**PROJECT:** Auburn Park Full Build-Out  
Montgomery County, VA Parks and Recreation

**GNI Job No.:** 2893.00

**DATE:** Thursday, March 28, 2024

**C2-08 SITE DETAILS**

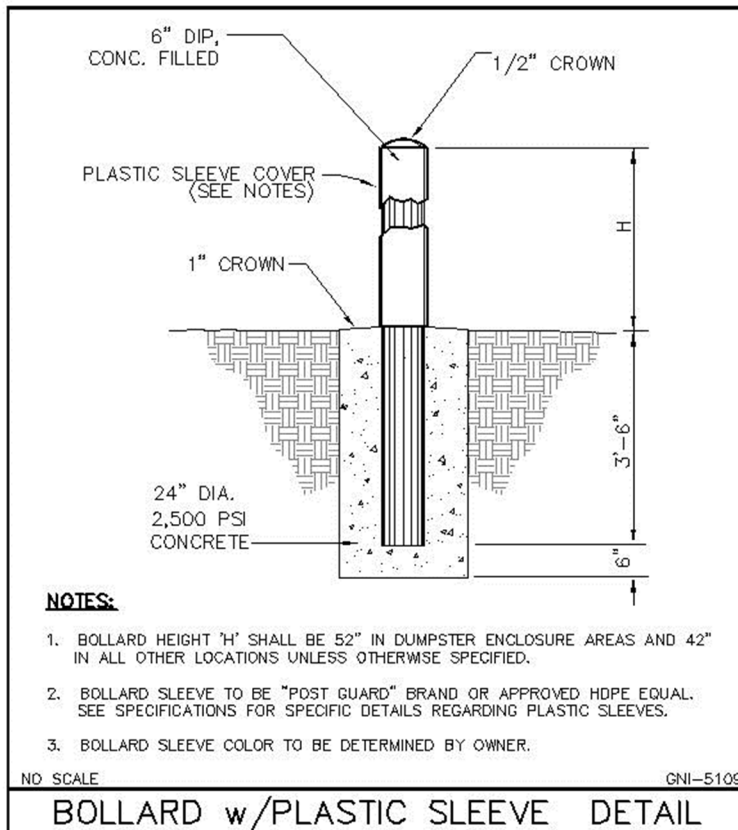
ADD "BOLLARD w/ PLASTIC SLEEVE DETAIL" as shown in the screenshot below.

**C3-09 PROPOSED STORM PROFILES**

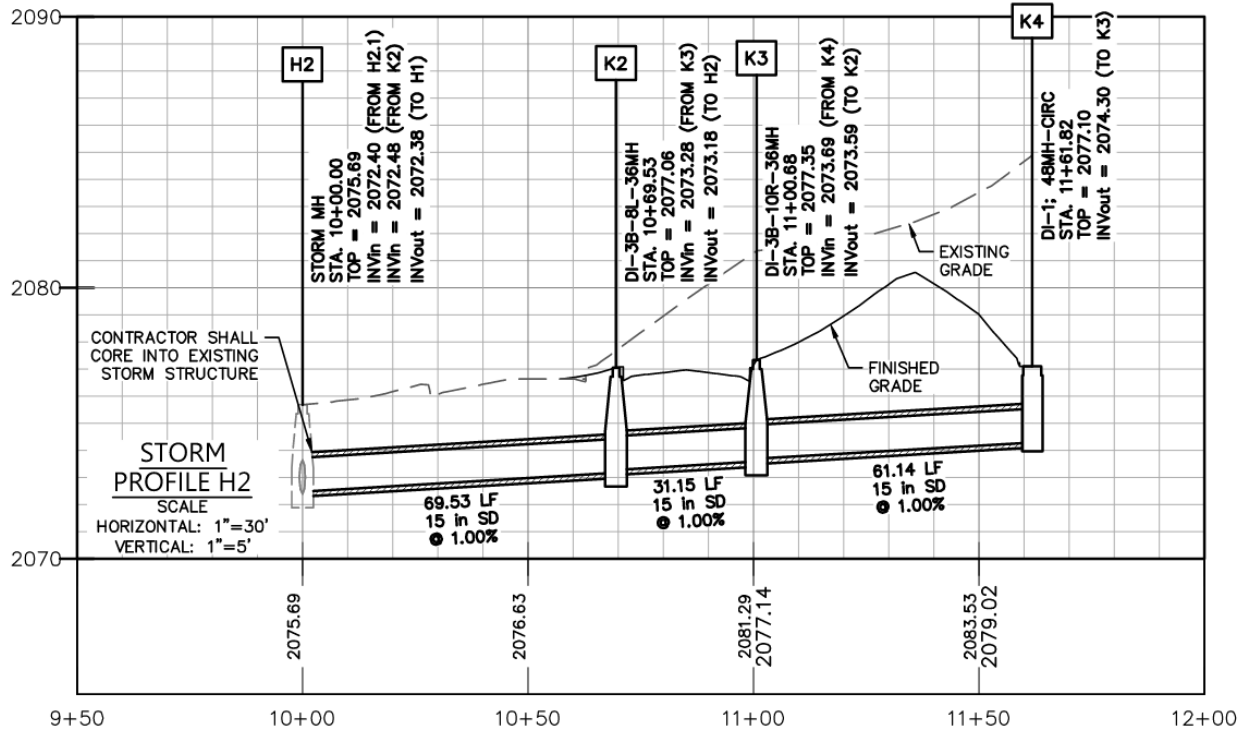
REVISE STORM PROFILE H2 as shown in screenshot below.
